**REVISIONS:** 01/14/2011

HOMEYER ENGINEERING, INC. - REGISTRATION NO. F-8440

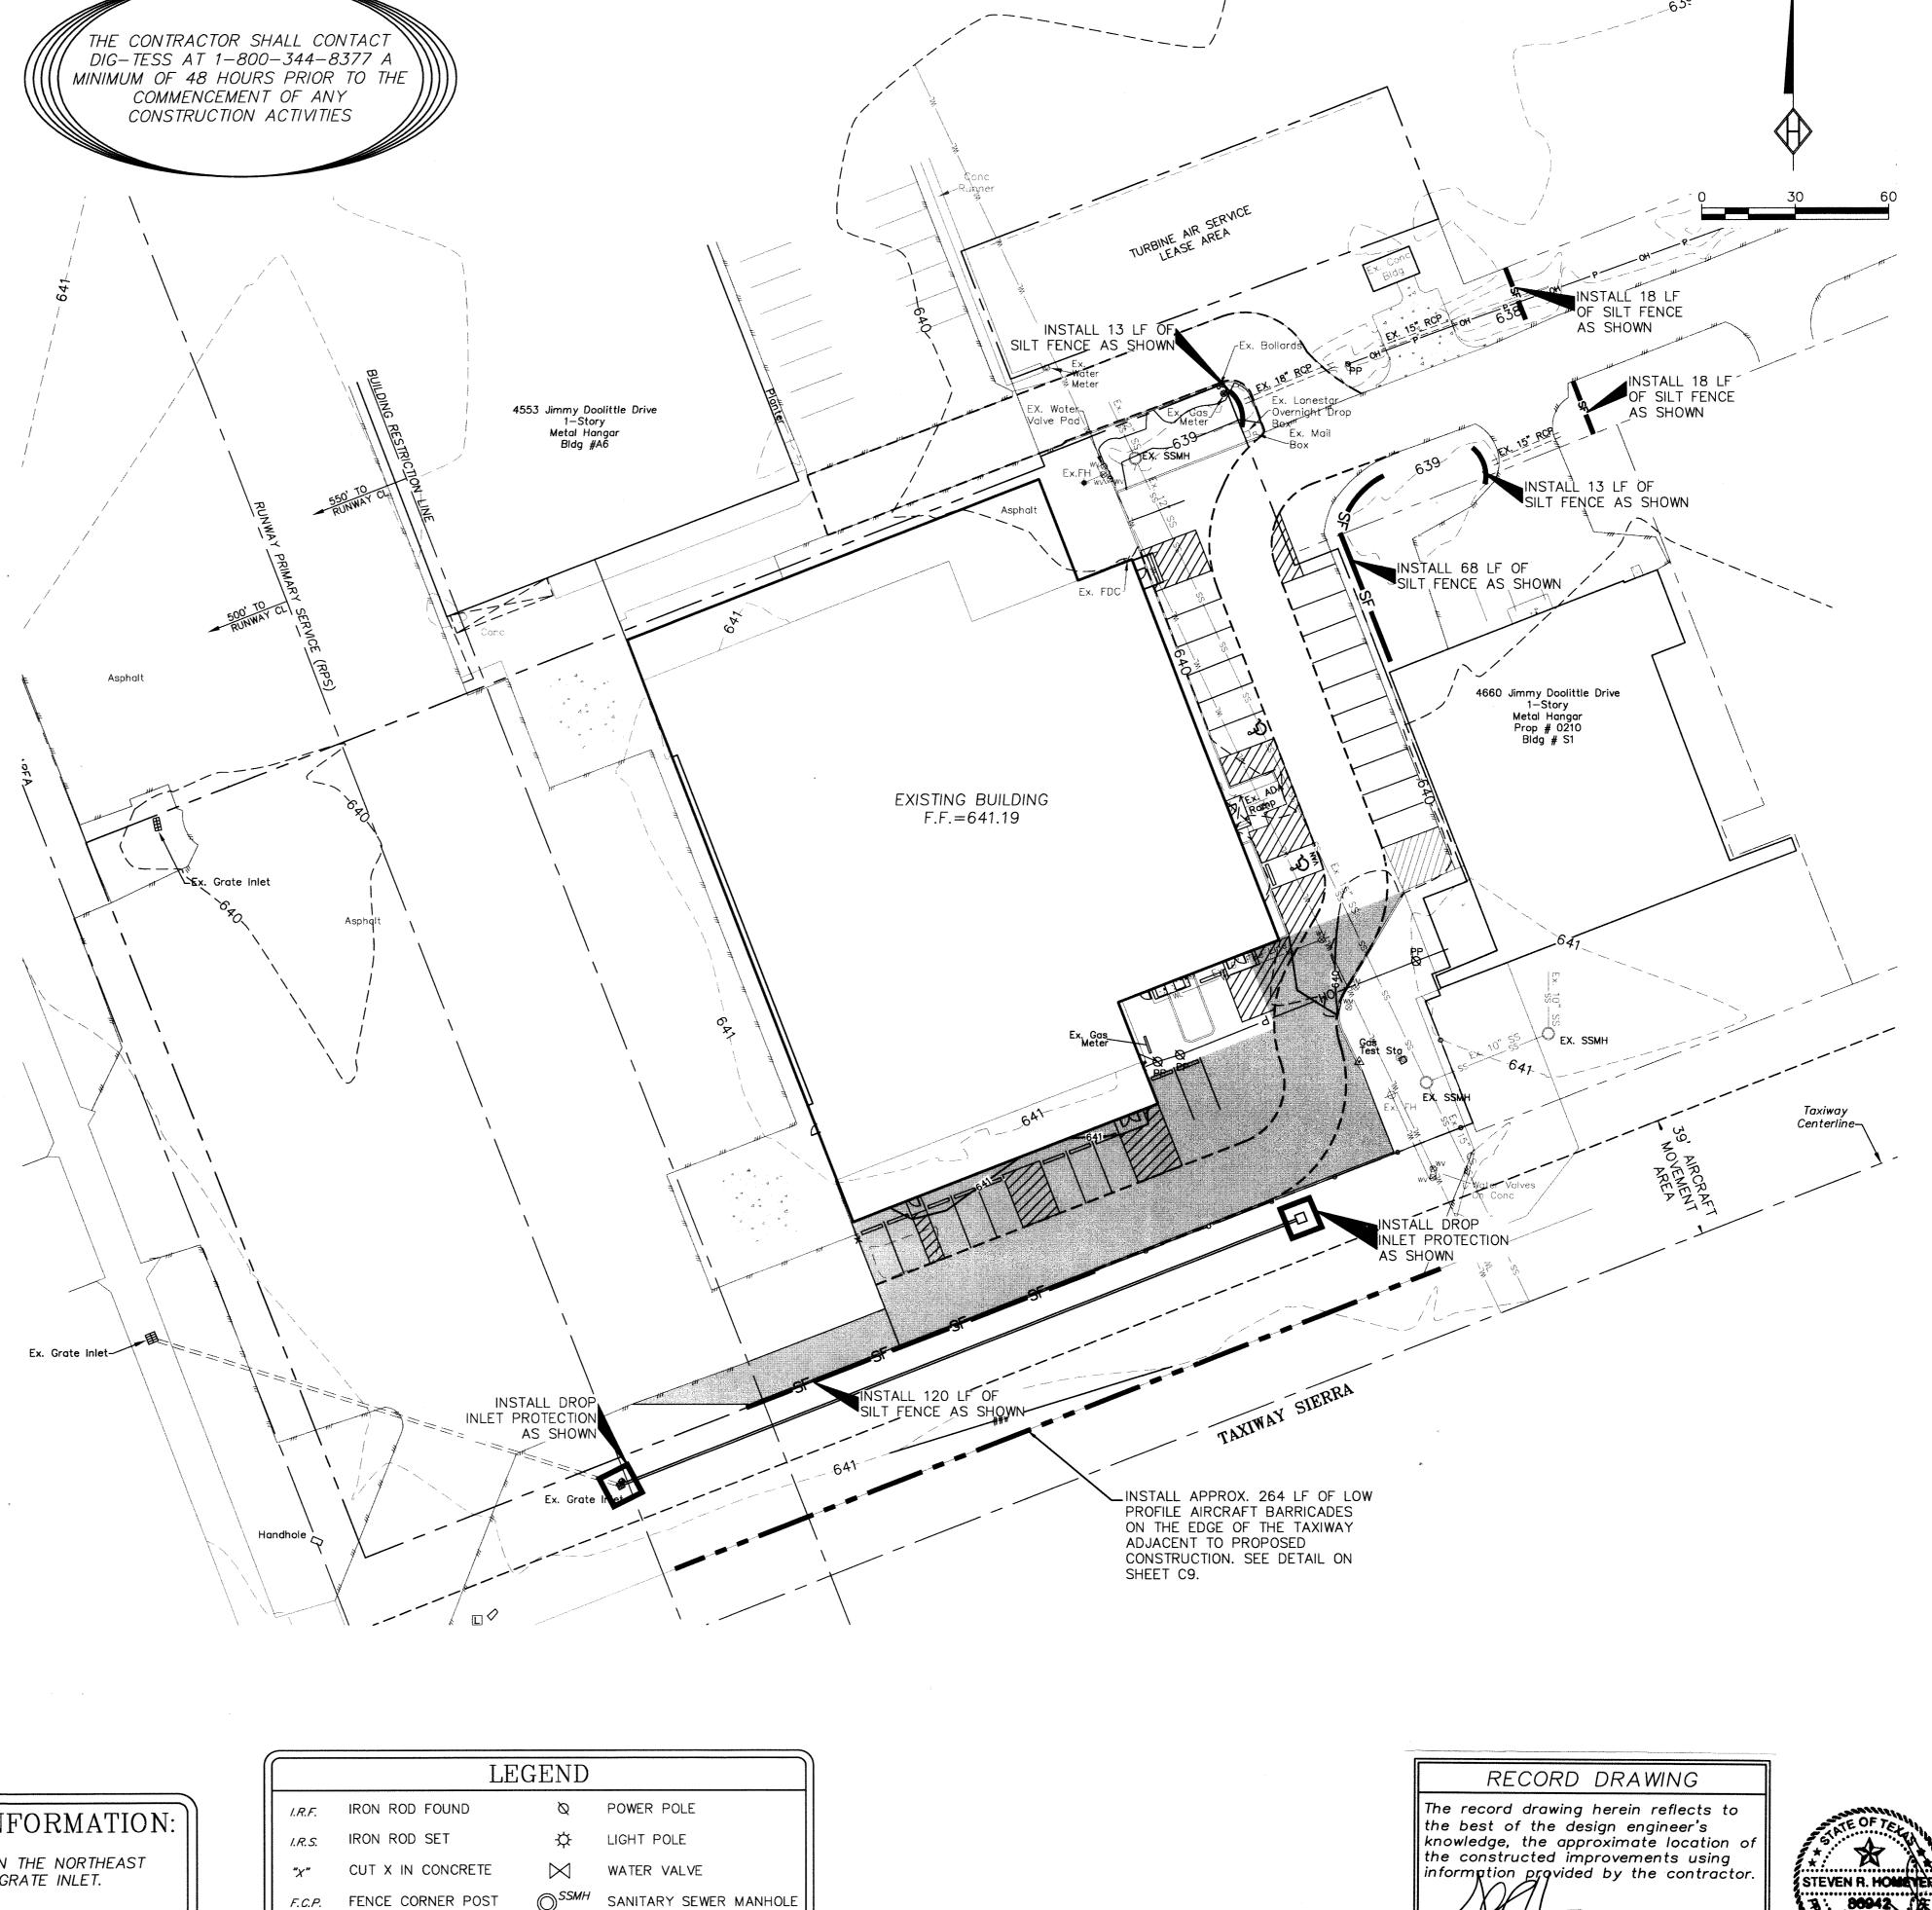
1. REVISED DROP INLET

PROTECTION TO MATCH RELOCATED

2. ADDED SILT FENCE ALONG SOUTHERN PARKING AREA.

INLET.
